**Overview:** Production error; immobilizer wire (orange/black) in pin position #4 instead of pin position #5. Although an effort to correct the issue was made, some quantity of harnesses did get shipped before the issue was spotted. We are advising to inspect the harness BLADE connector before attempting to install the harness and program the module.

**Descripción general:** El nuevo arnés en T FTI-STP1 requiere modificaciones para su uso en aplicaciones de transmisión automática (AT).

# FTI-STP1: Notas de preparación y cobertura del vehículo

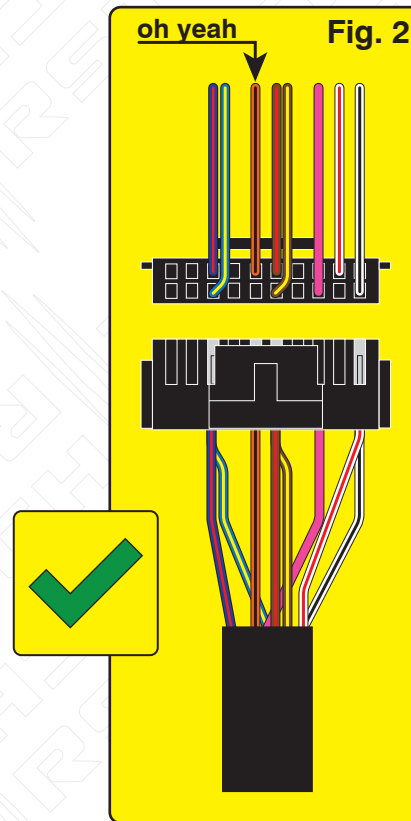
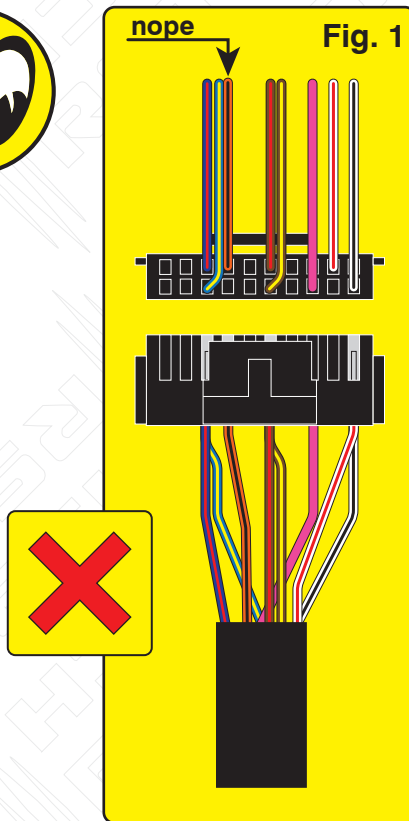
**Issue:** Module fails to program to vehicle, will not allow the vehicle to be remote started.

**Correction:** Step 1.) Locate the orange/black wire and confirm whether it is positioned as illustrated in Fig. 1 or Fig. 2. If the wire is as illustrated in Fig.1, proceed with Step 2 through 5 and complete the repair procedure outlined, if the wire is as illustrated in Fig. 2, correction is not necessary, proceed with harness installation and module programming.

**Step 2.)** Using a pick, lightly depress the catch that secures the terminal in the housing then remove the wire and terminal from the housing.

**Step 3.)** Using a fine tip razor or utility knife, insert the blade beneath the terminal catch and raise it slightly, so that it can be reused to secure the terminal when reinserted into the BLADE connector housing.

**Step 4.)** Refer to Fig. 2 for correct position of the orange/black wire (next to brown/red) then reinsert the terminal, pressing lightly until the catch 'snaps' into place, securing the terminal in the connector housing.

**Step 5.)** The repair is complete, proceed with installation and programming.

**MODIFICACIÓN REQUERIDA PARA APLICACIONES DE TRANSMISIÓN AUTOMÁTICA ÚNICAMENTE**

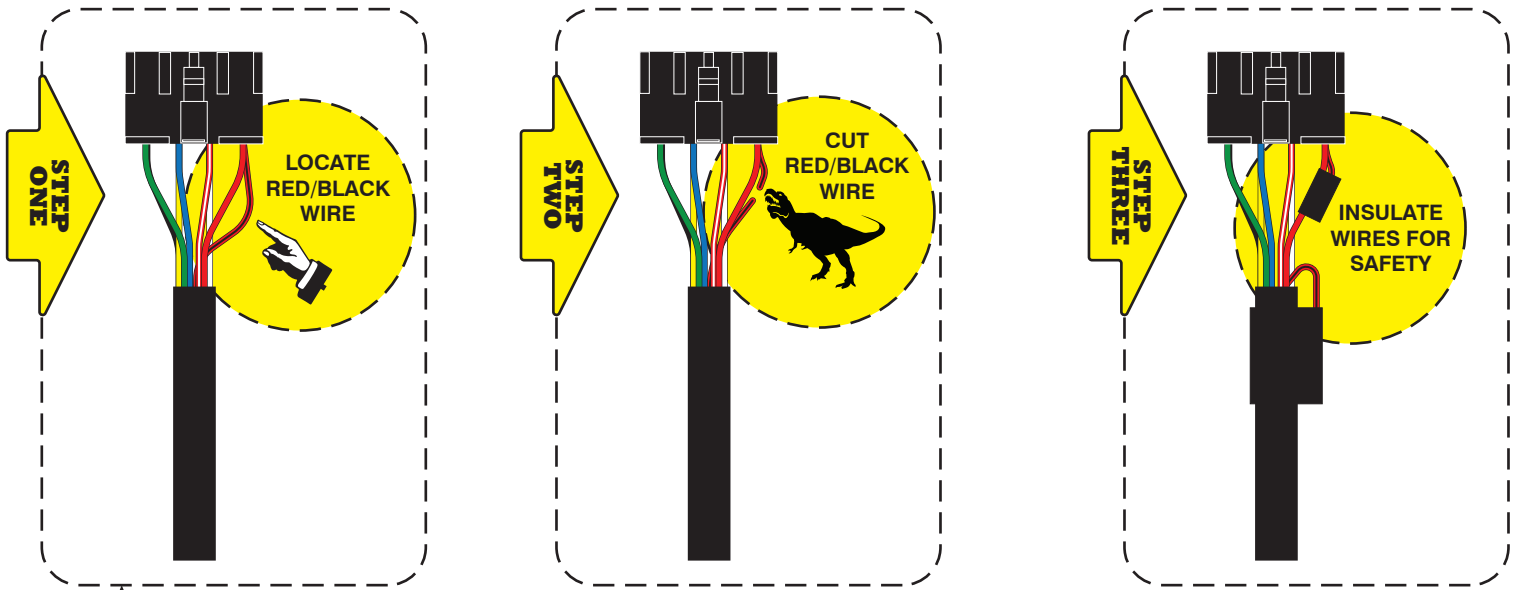
**Problema:** El arnés en T FTI-STP1 ha sido diseñado para ser compatible con AT (transmisión automática) y MT (transmisión manual), pero debido a una supervisión de la producción, el mecanismo de selección se estableció por defecto en el modo MT.

*El uso de un arnés configurado para una aplicación MT, en un vehículo equipado con AT, podría provocar daños en el módulo del vehículo. Se recomienda que el arnés vuelva al modo AT antes de instalarlo en vehículos equipados con transmisión automática.*

**Corrección:** Localice el cable rojo/negro (+ embrague) provisto en el conector CN1 del conjunto del arnés principal. Corte el cable rojo / negro, ya sea al ras del conector CN1 o dejando suficiente cable expuesto para que pueda aislar y asegure los extremos del alambre que quedan después del corte. Aísle cada uno de los extremos restantes del cable rojo/negro y asegúrelos para evitar cualquier posibilidad de cortocircuito.
